SECRET NUMBER  
PROPOSED RULE PR-60

Department of Energy  
Washington, D.C. 20545

MEMORANDUM FOR Mr. Samuel Chilk  
Secretary, Nuclear Regulatory Commission  
Attention: Docketing and Service Branch  
Washington, D.C. 20555

COMMENTARY ON MAJOR ISSUESOFFICE OF SECRETARY  
DOCKETING & SERVICE  
BRANCH

Figure 1

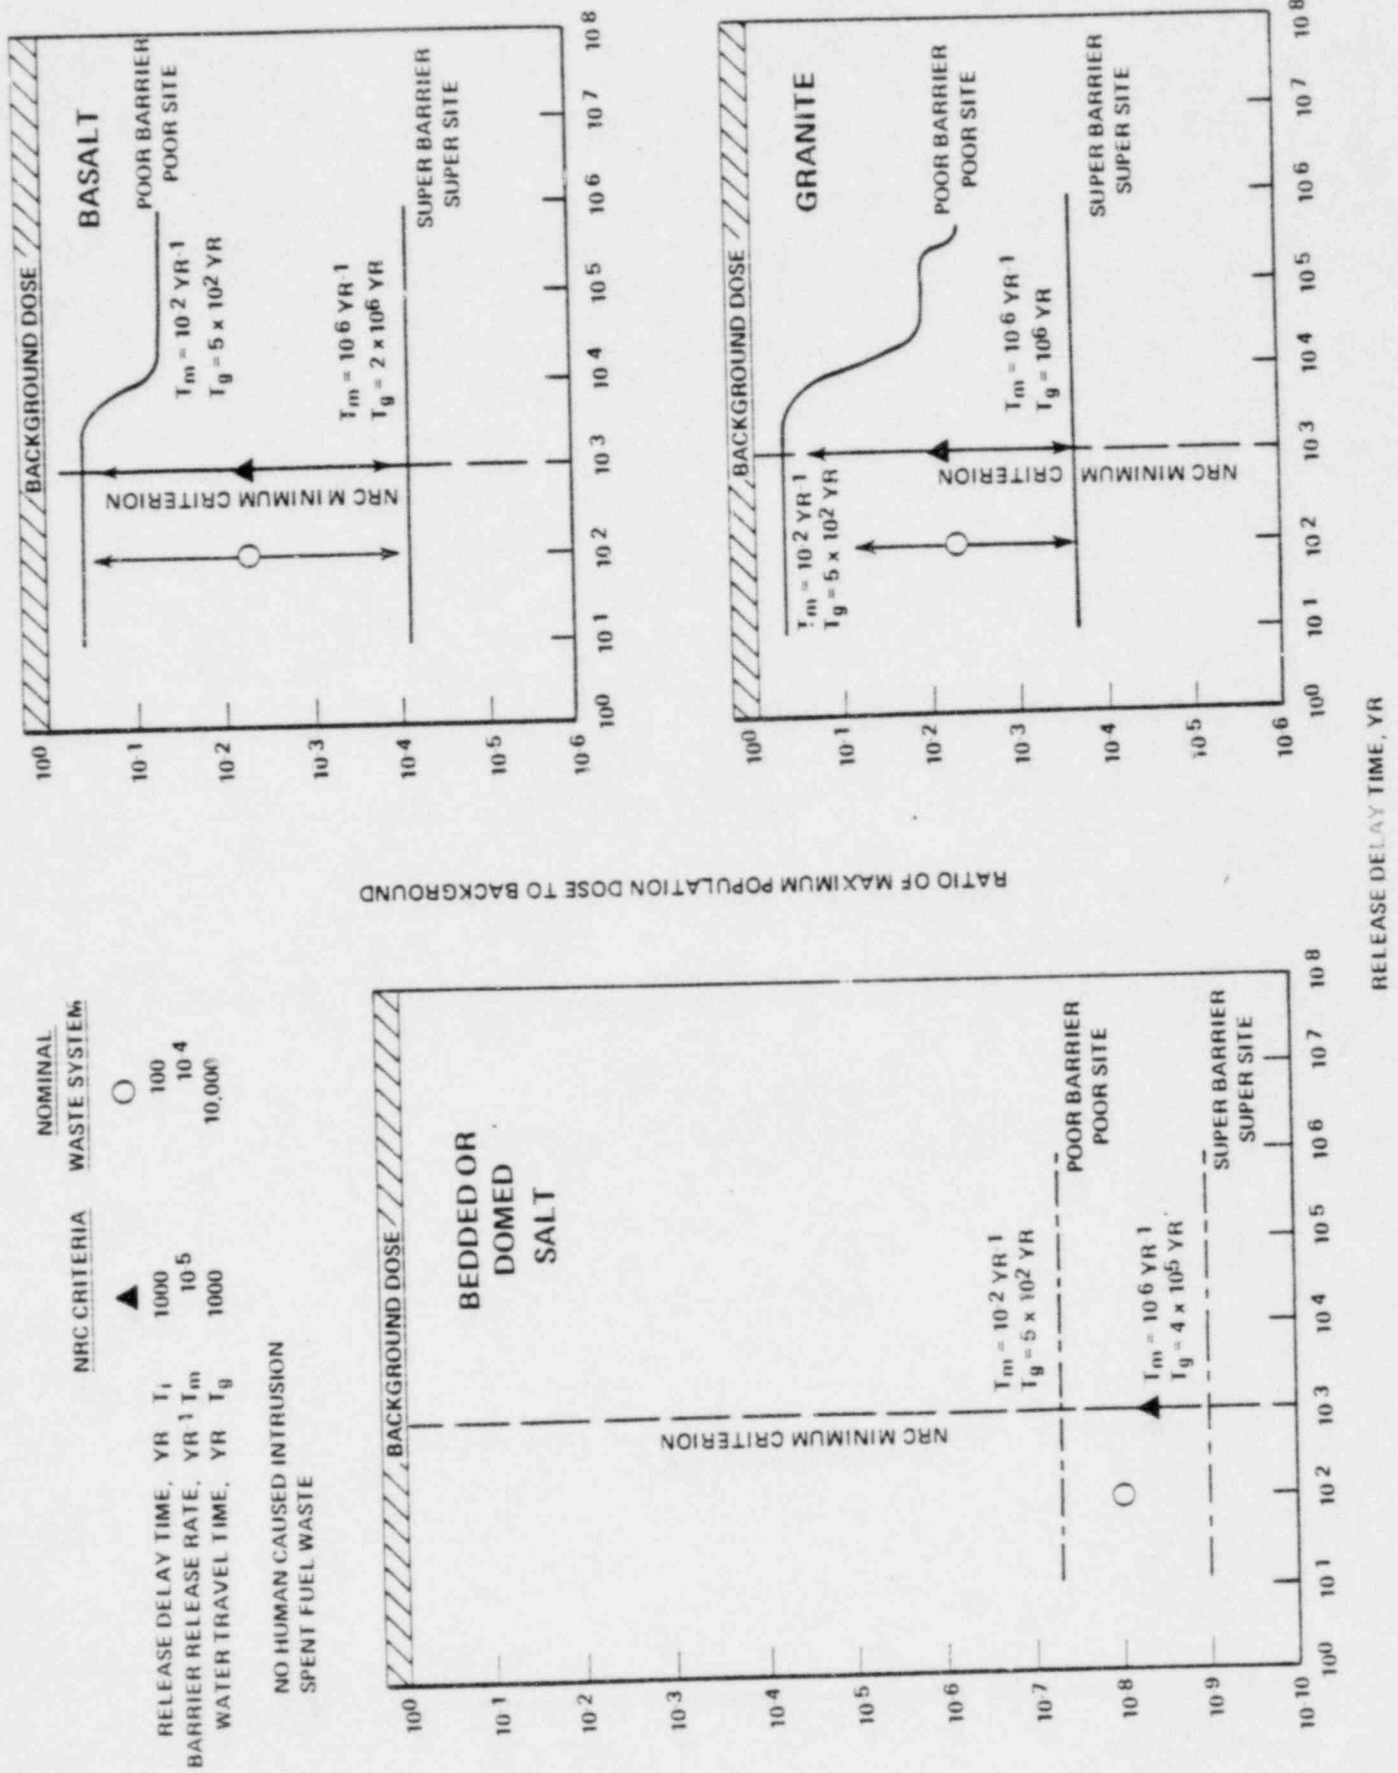
The effect of varying the delay time for water to penetrate the containment over a range of five orders of magnitude is shown in Figure 1. For all three geologic environments, the analysis shows that the effect of a 1,000 year lifetime package is not significantly different from that of a 100 year lifetime package. In all cases the analysis indicates that the maximum exposure is below background.

Figure 2

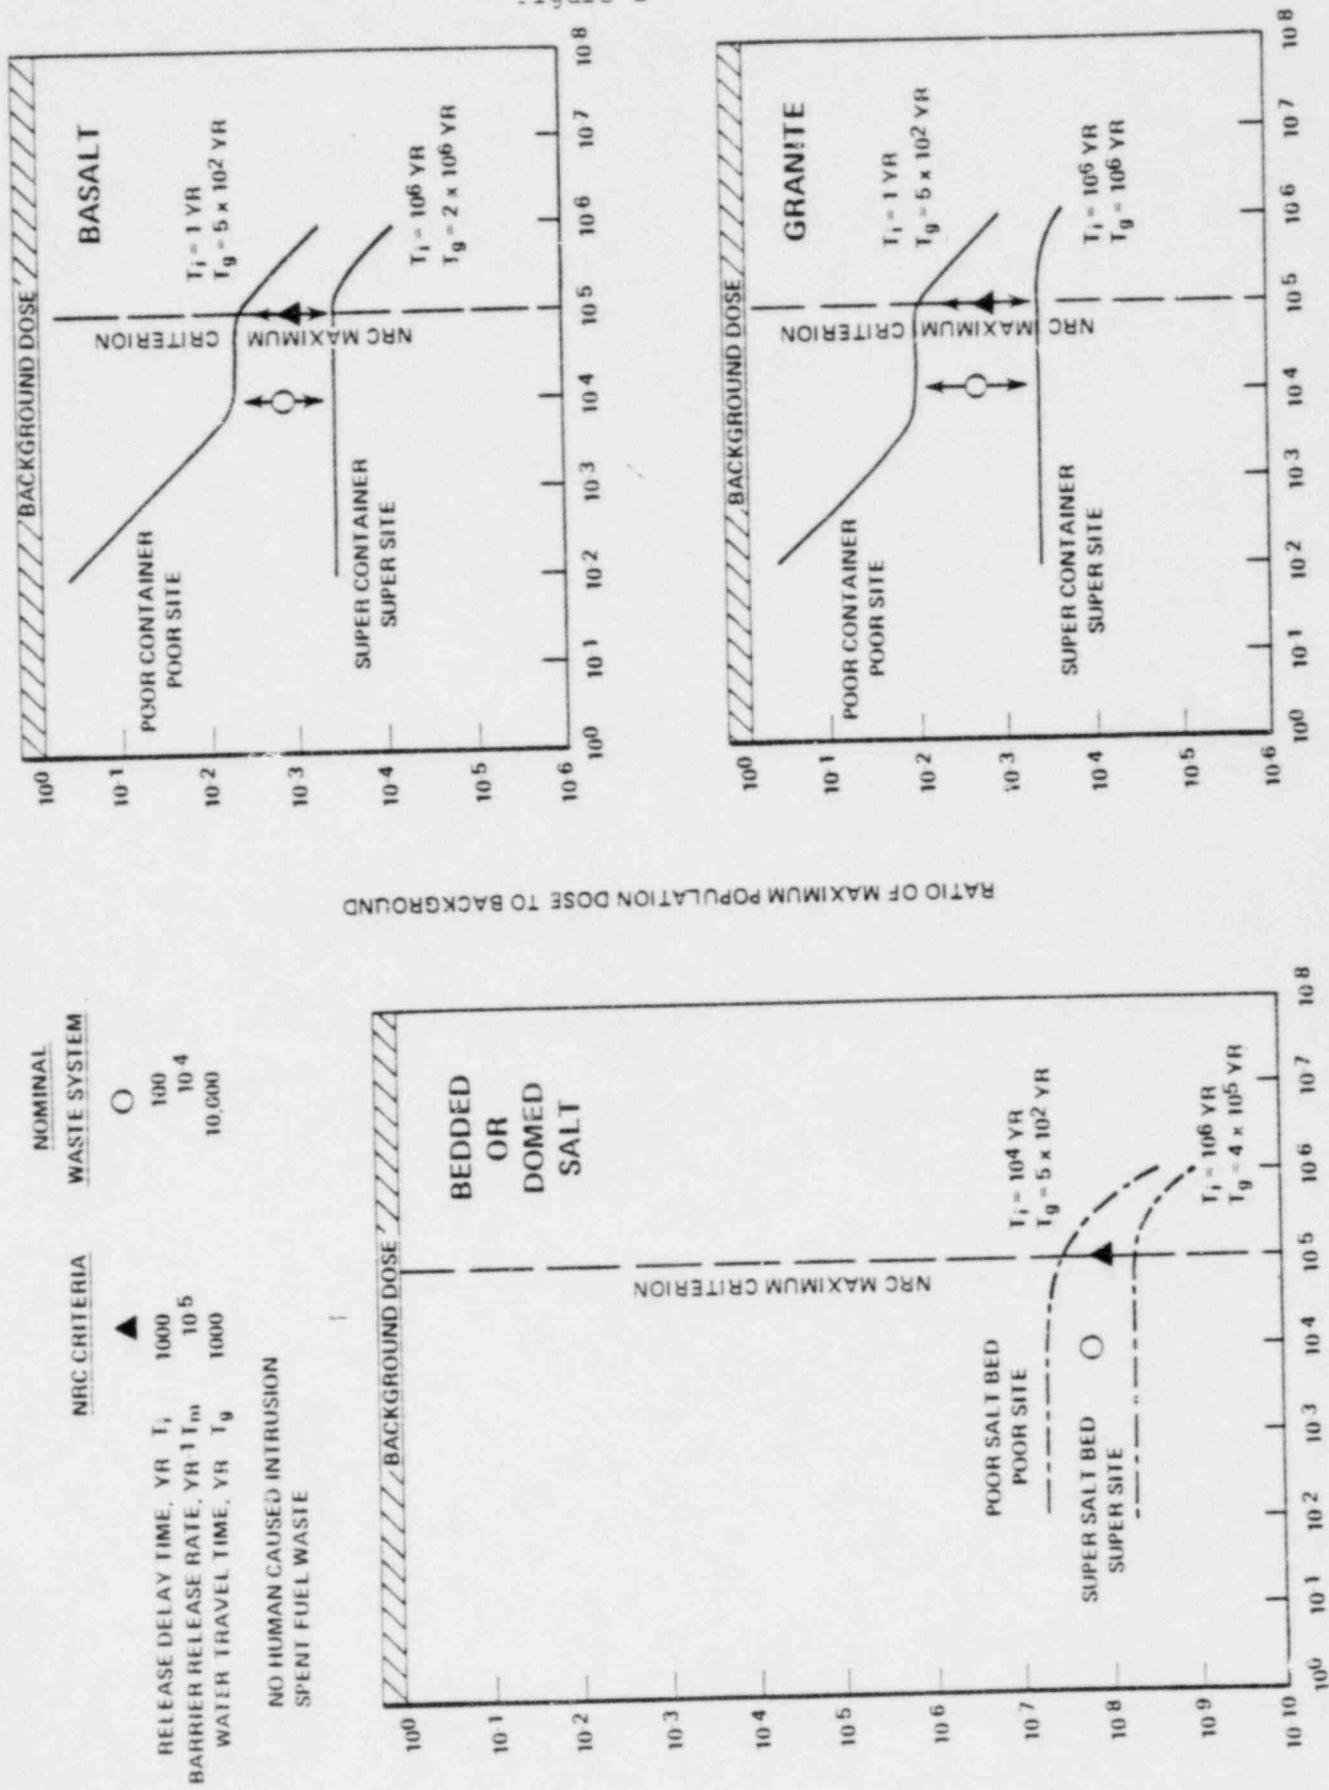
Once containment has been breached, the effect of varying the release rate over a range of four orders of magnitude is shown in Figure 2. There is no significant change in calculated population dose as the waste release rate is increased from the proposed maximum criterion of  $10^{-5}$  fraction per year to a rate of  $10^{-4}$  per year for a nominal repository. Of course, further reductions of release rate toward the theoretical zero release would marginally reduce computed release to the accessible environment, but it is very doubtful that the additional reduction in the maximum exposure below the already extremely low level would be justified.

Figure 3

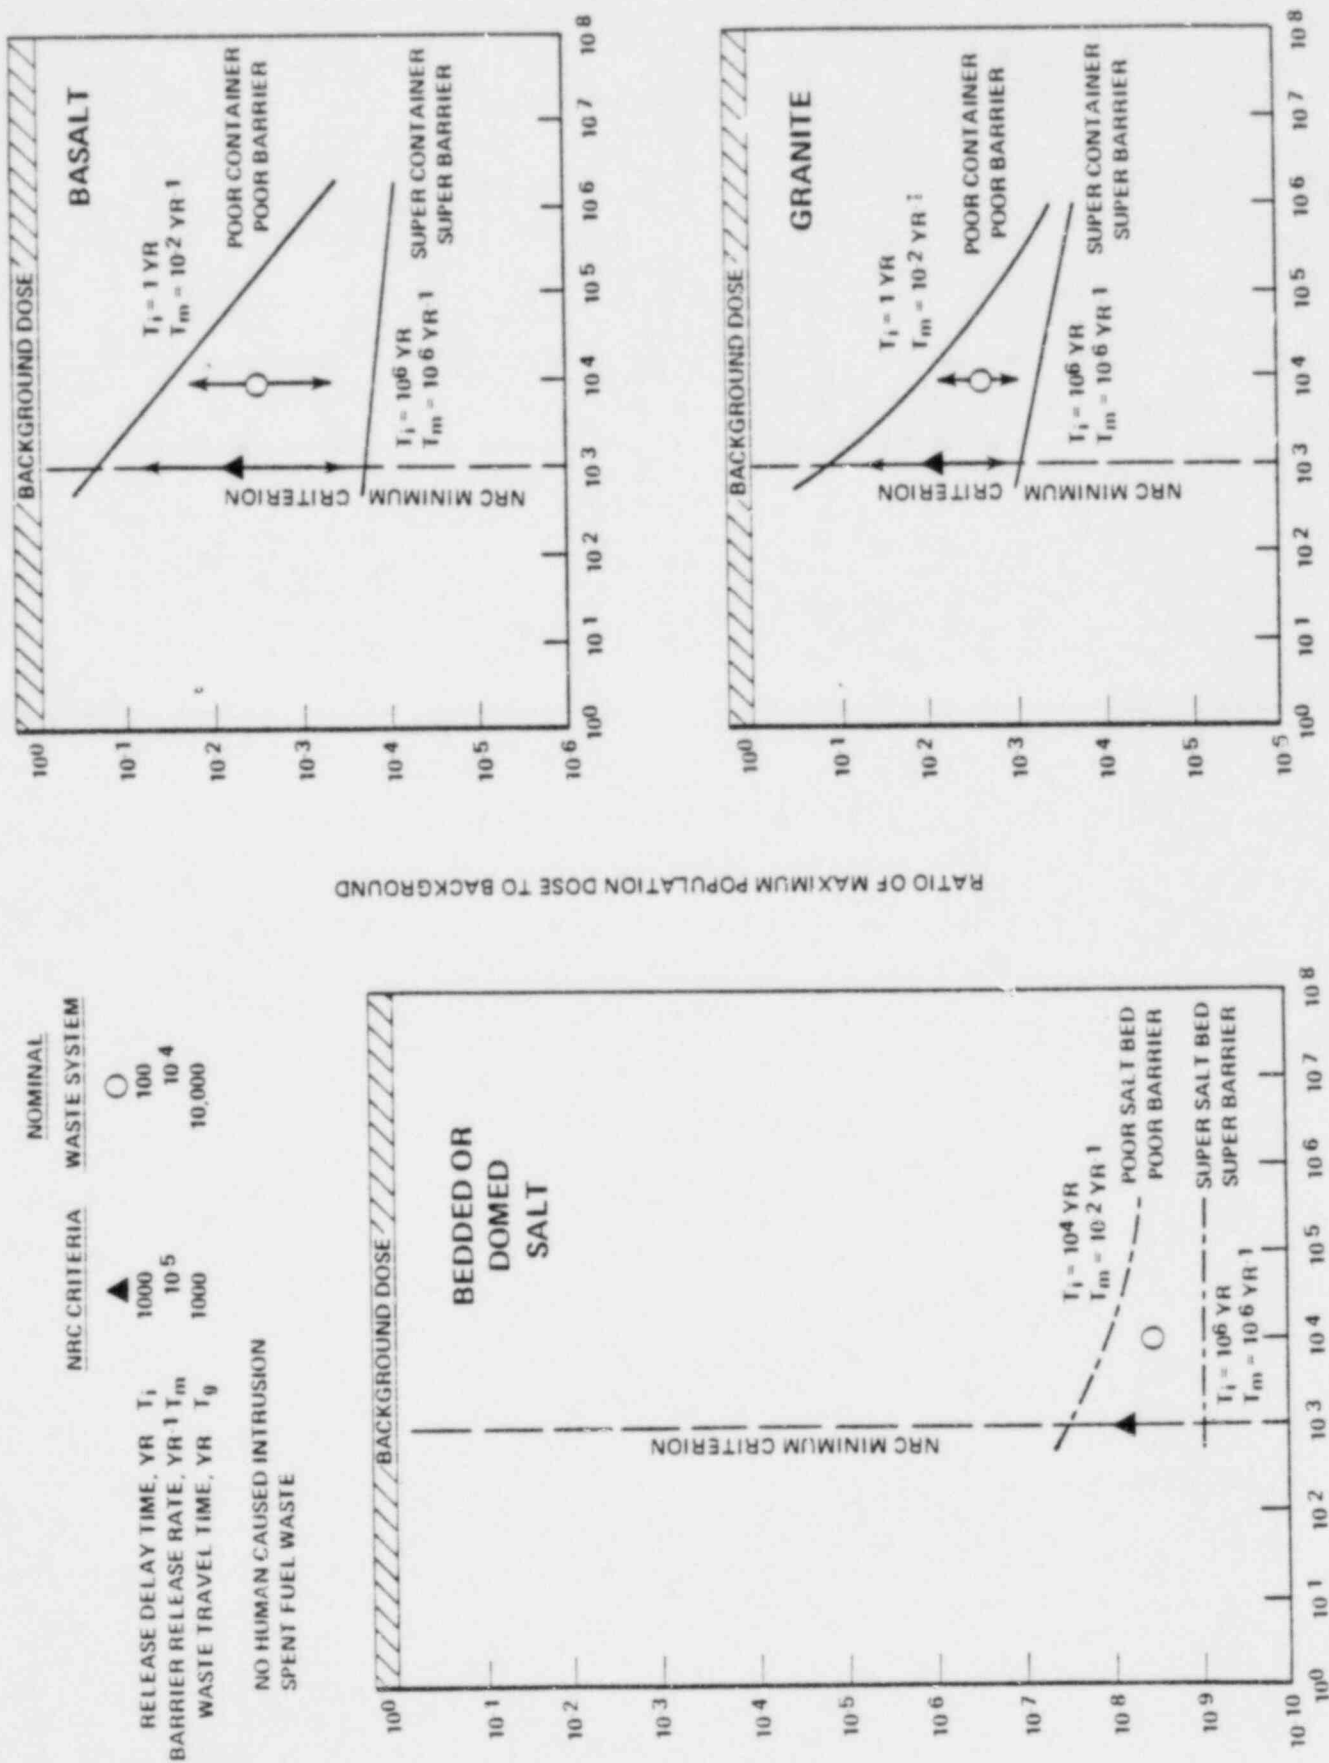
The effect of varying the groundwater travel time from the waste to the biosphere over a 3,000-fold range is shown in Figure 3. The population dose decreases as the travel time is increased over the entire range for both extremes. Thus, it can be seen that the isolation system is by far more sensitive to groundwater travel time than to the performance of the engineered barriers.
